8-10 New McLean Street

Urban Design Study

Prepared for
DPHI

Issued
June 14 2024

Views have been recreated from Urbaine Design Group’s visual impact assessment report to demonstrate a comparative assessment between the preferred approach and the planning proposal massing.

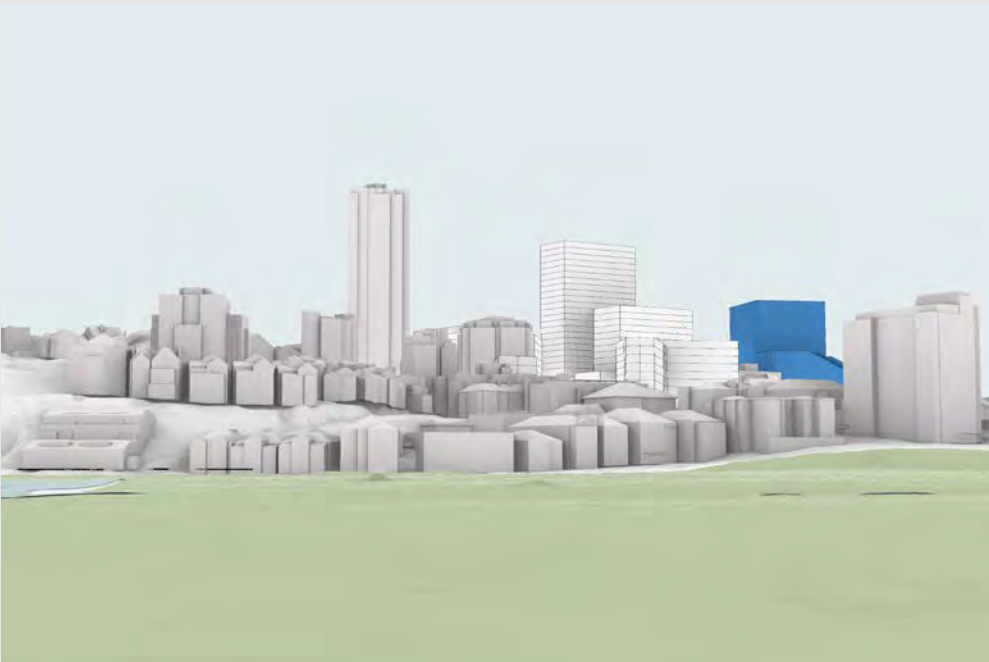
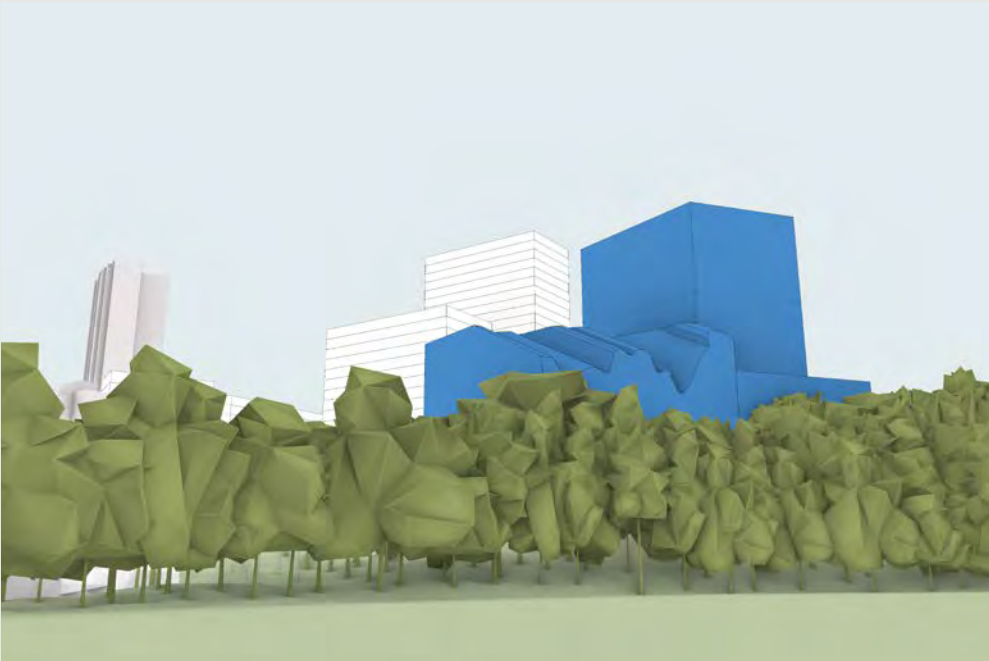
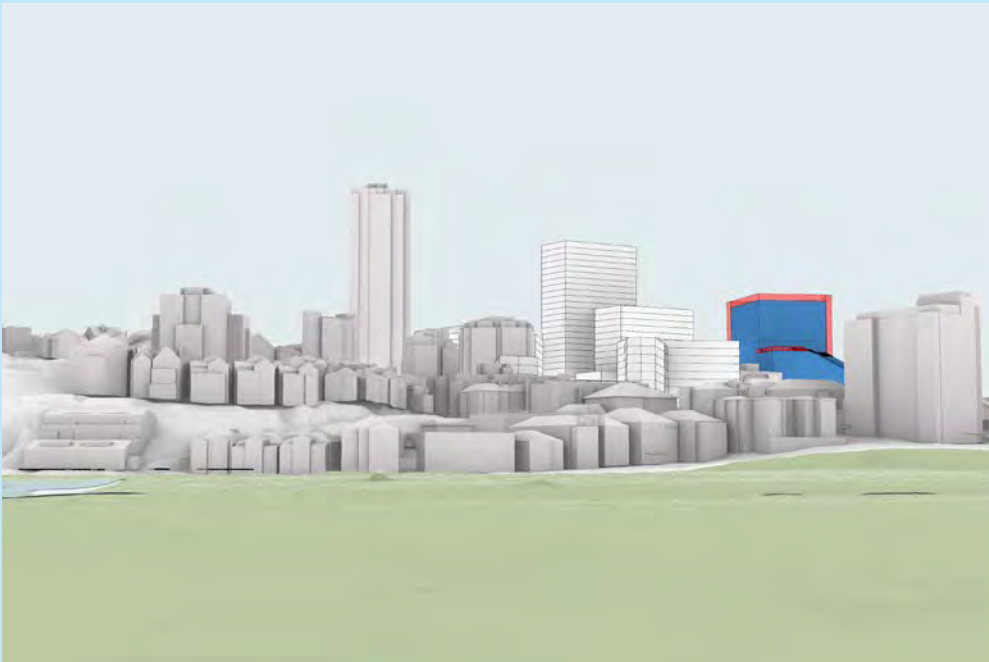
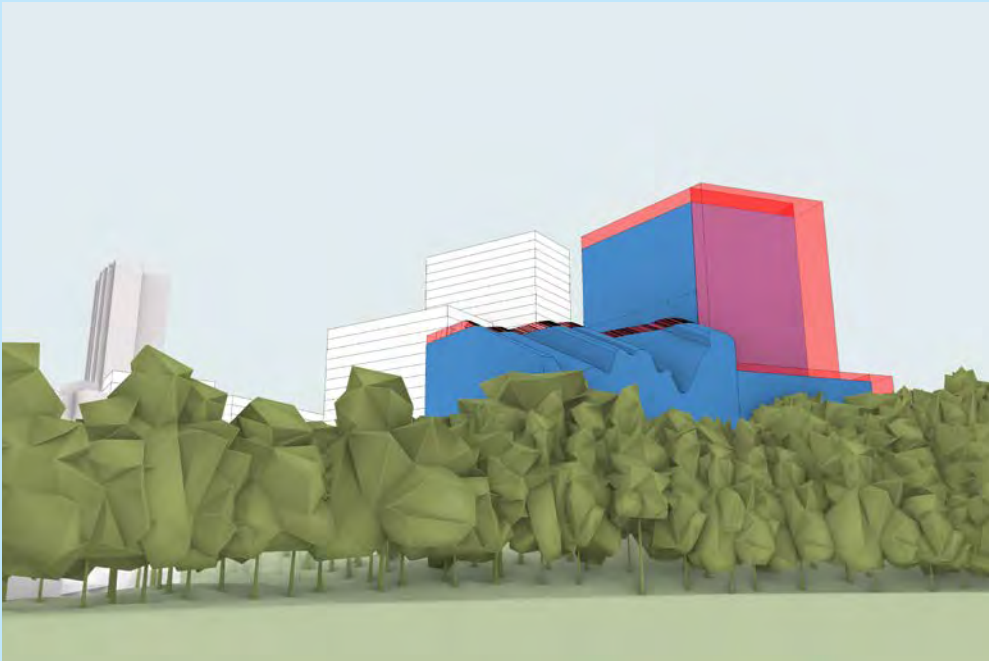
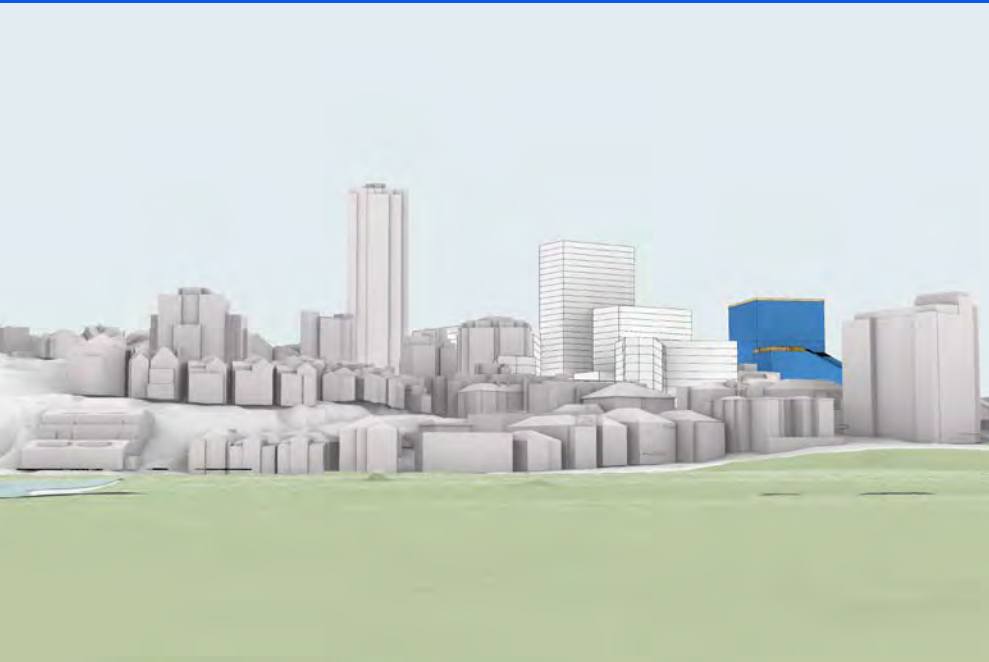
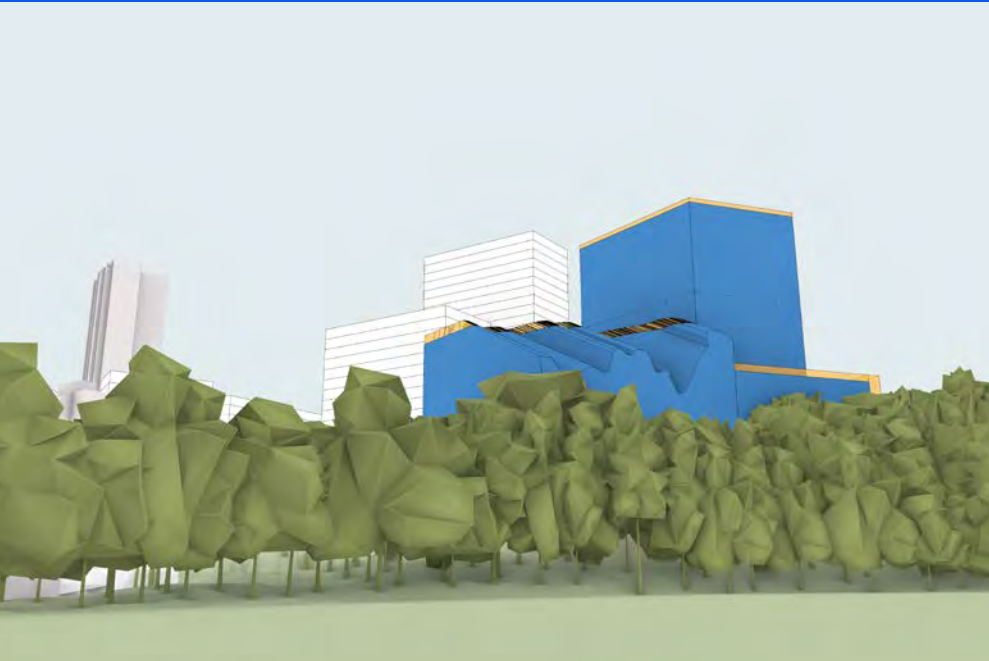
In maintaining the current tower envelope, the visual impacts are significantly reduced. Views from Rushcutters Bay Park maintain an appropriate transition between the ECC massing and surrounding areas with a similar effect taking place when viewed from Trumper Park. By maintaining the initial tower footprint the reduction in visual impact from the southern corner of the tower envelope is evident from this view.
